Amberfield S92 Response

Landscape / Visual Effects / Open Space
Prepared for Weston Lea Ltd

17 August 2018

141842-SK301	Earthworks overlay Plan Sheet 1 of 6
141842-SK302	Earthworks overlay Plan Sheet 2 of 6
141842-SK303	Earthworks overlay Plan Sheet 3 of 6
141842-SK304	Earthworks overlay Plan Sheet 4 of 6
141842-SK305	Earthworks overlay Plan Sheet 5 of 6
141842-SK306	Earthworks overlay Plan Sheet 6 of 6

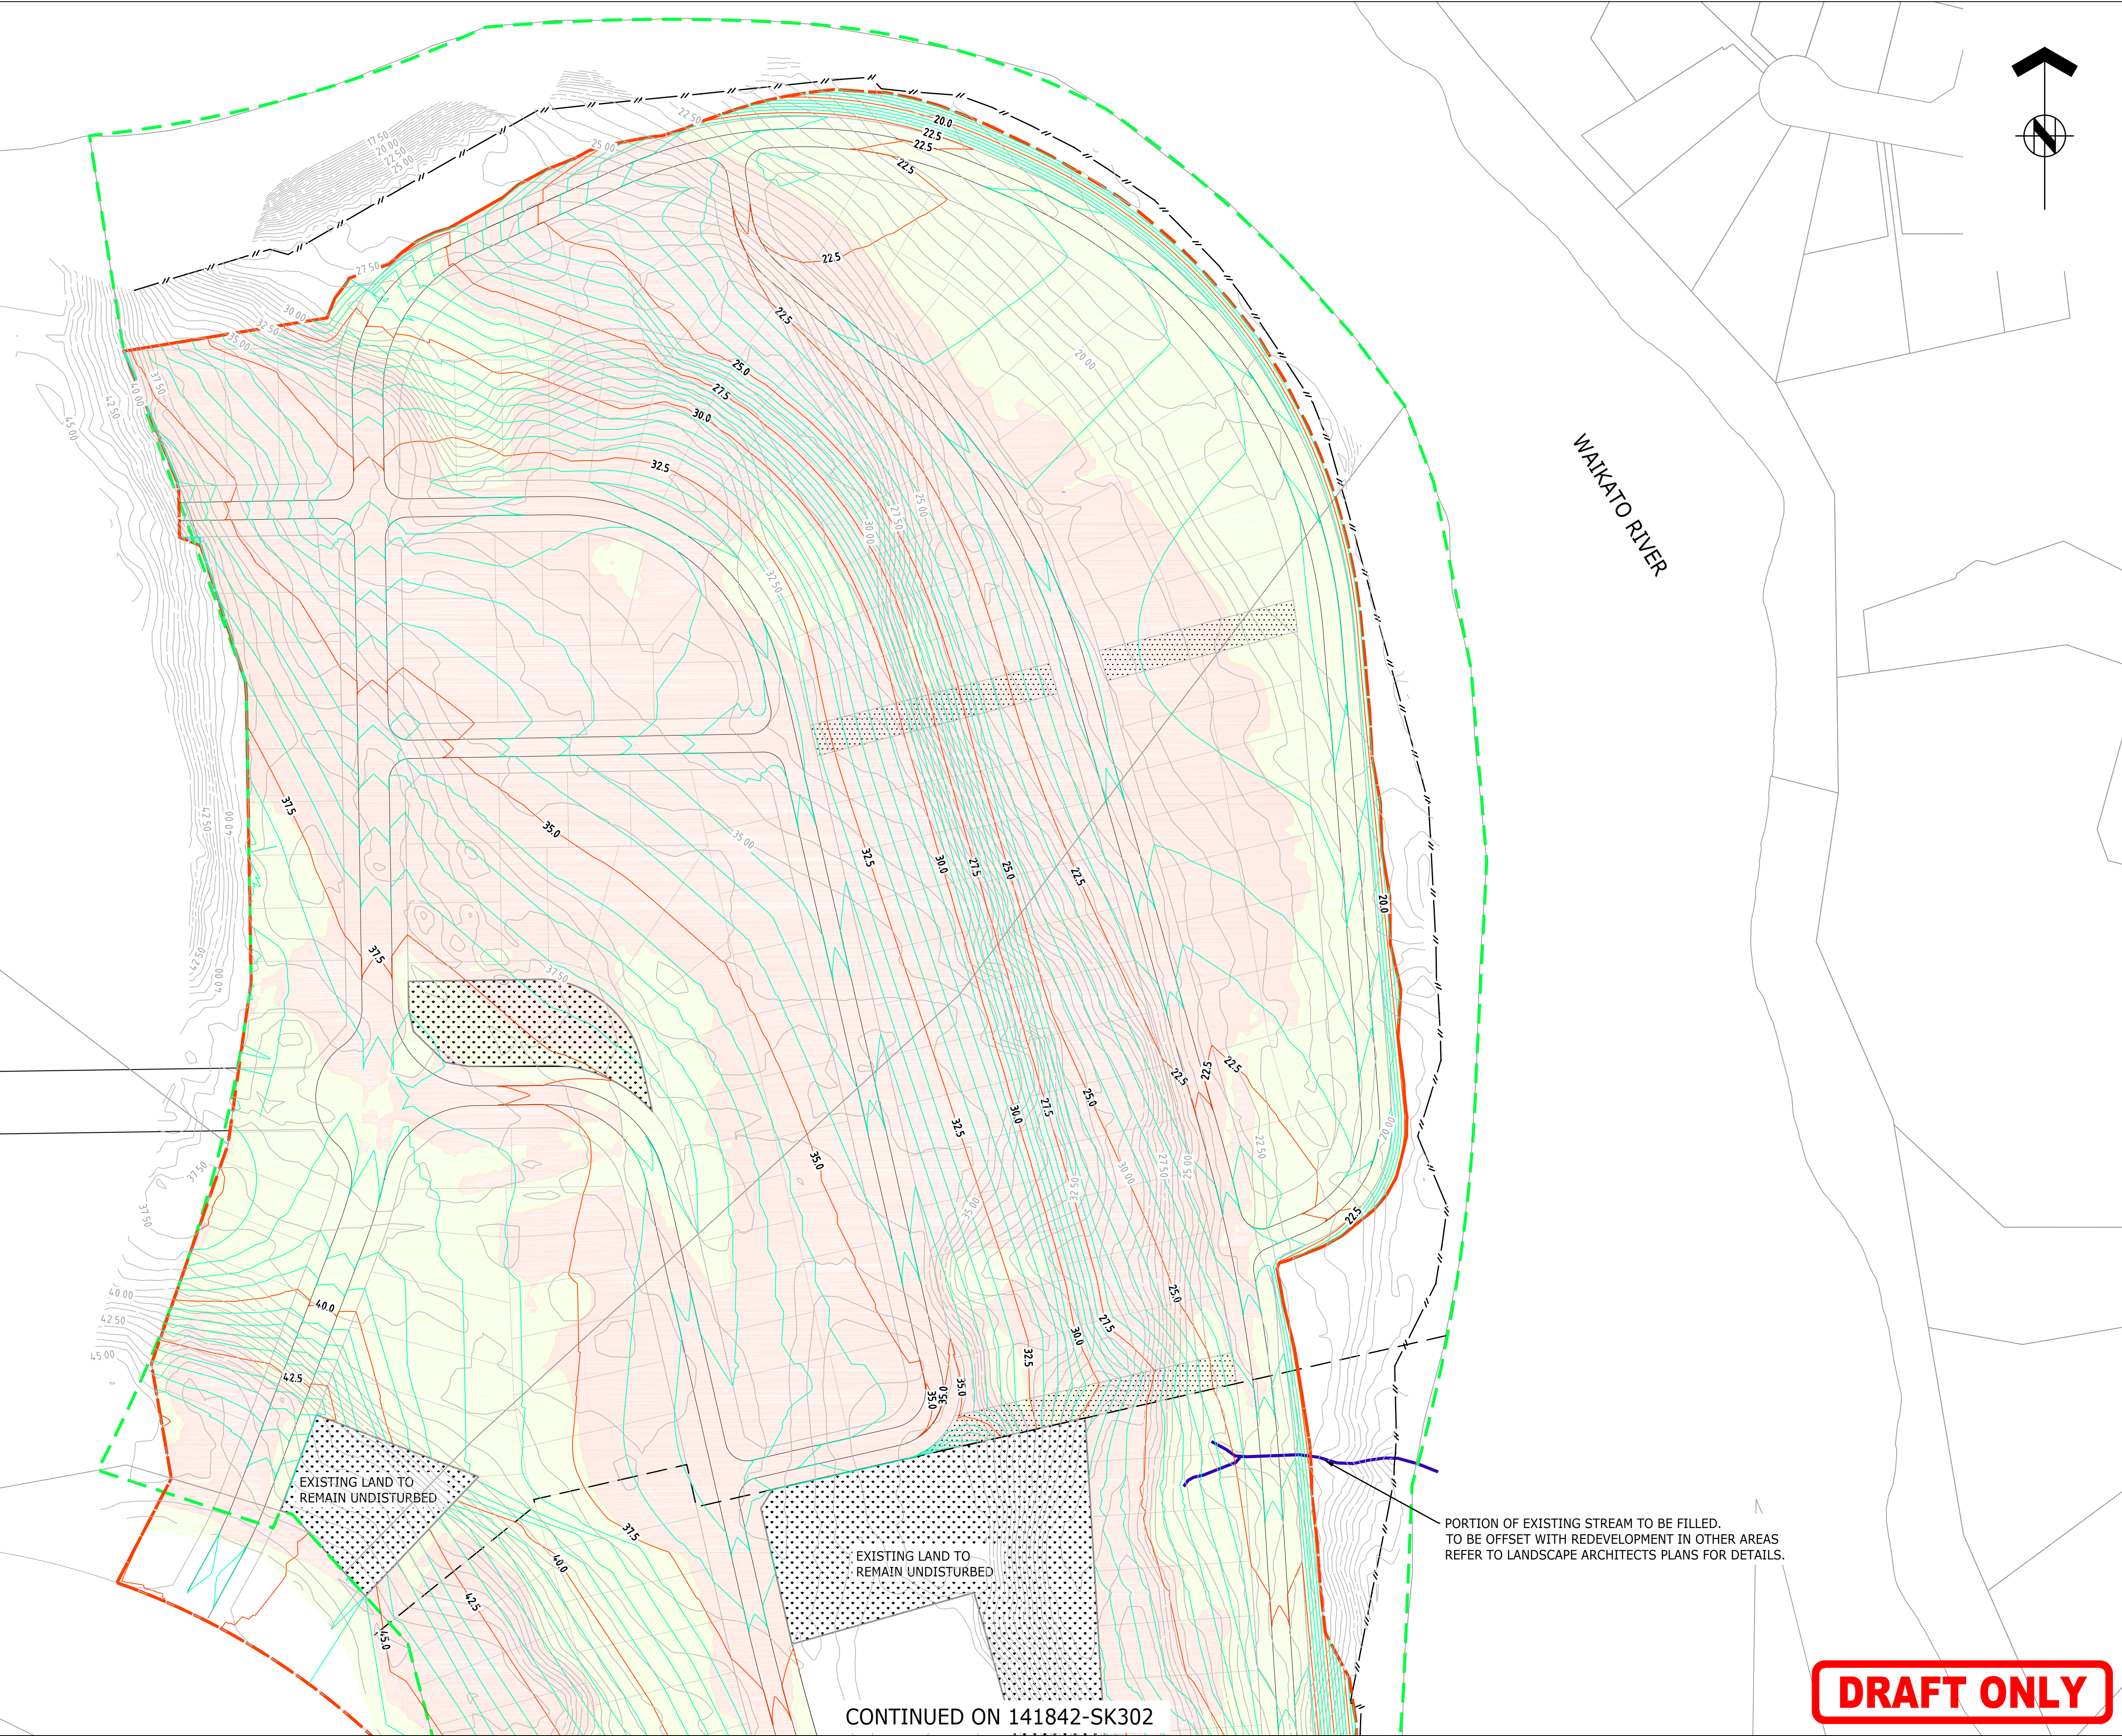
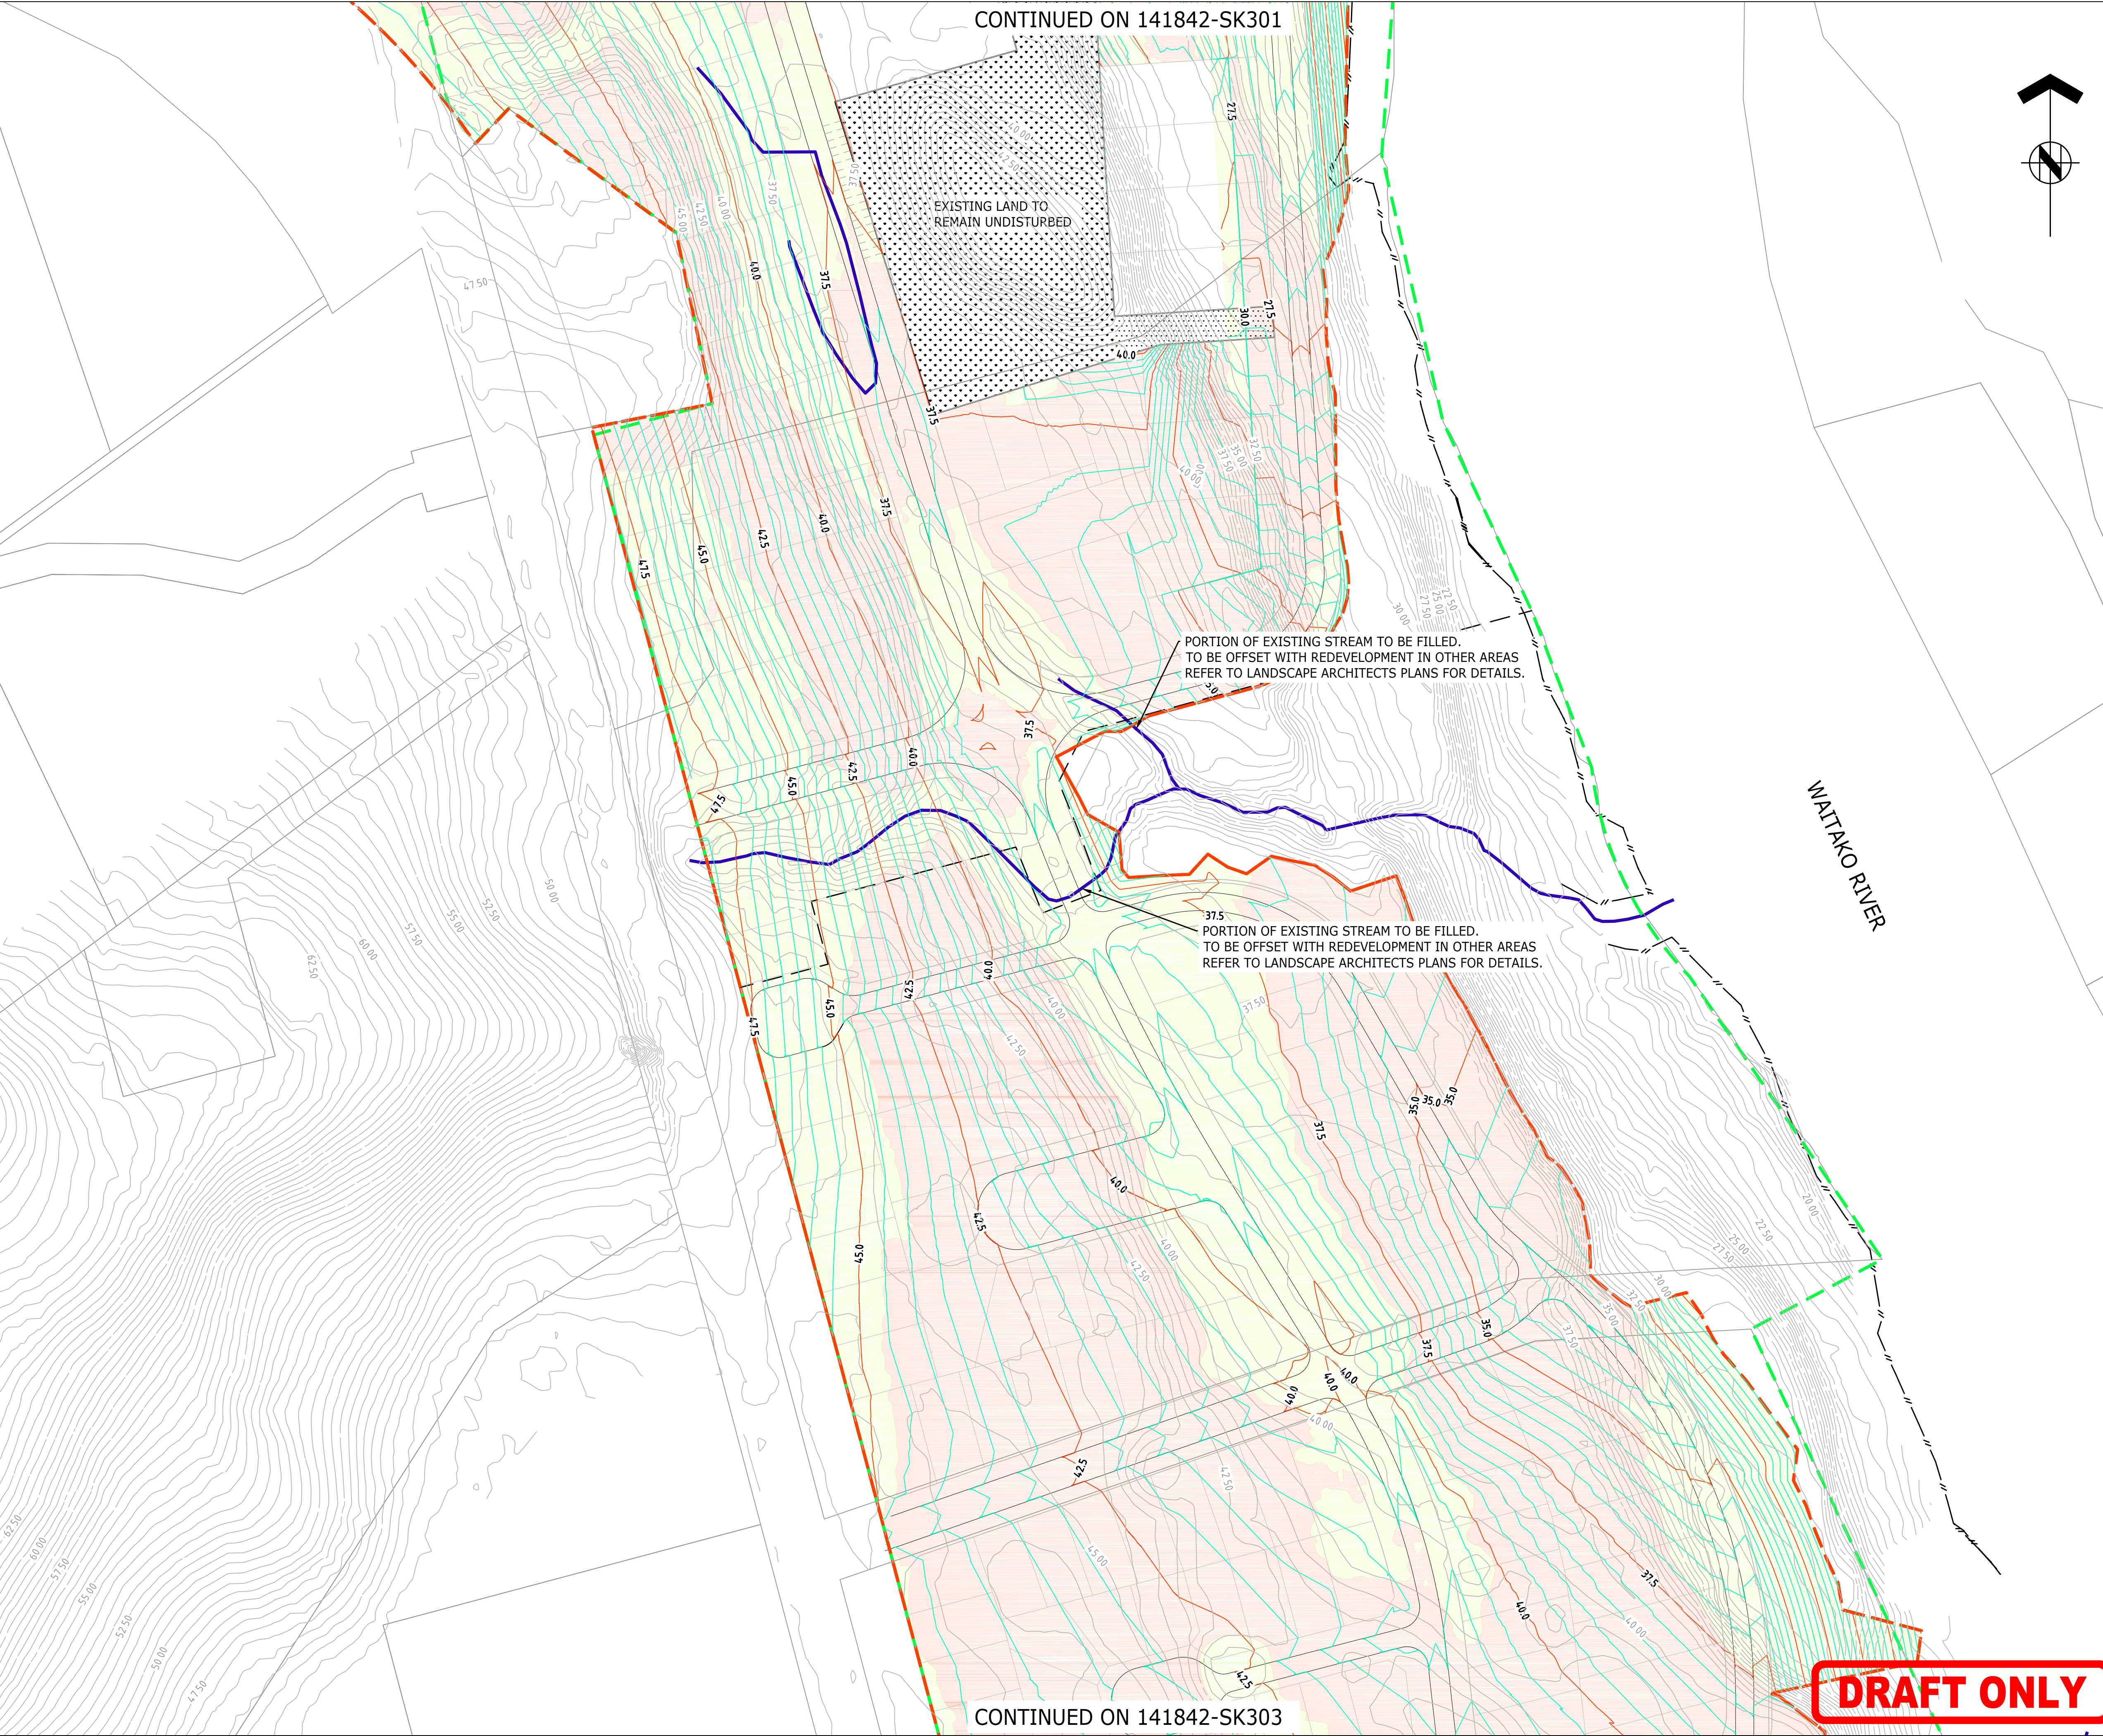
The additional H&G Cut and Fill drawings; 141842-SK301 to SK306, now clearly showing the existing and proposed contours, show the general smoothing off of the landform consistent with earthworks to enable urban development, the grading to achieve street gradients / connections and the proposed terracing of the site. As already noted the greatest level of modification is to 'The Island' landform which will remain strongly defined by the gully system to the west and river corridor to the east retaining the separate identity of this part of the overall site topography.
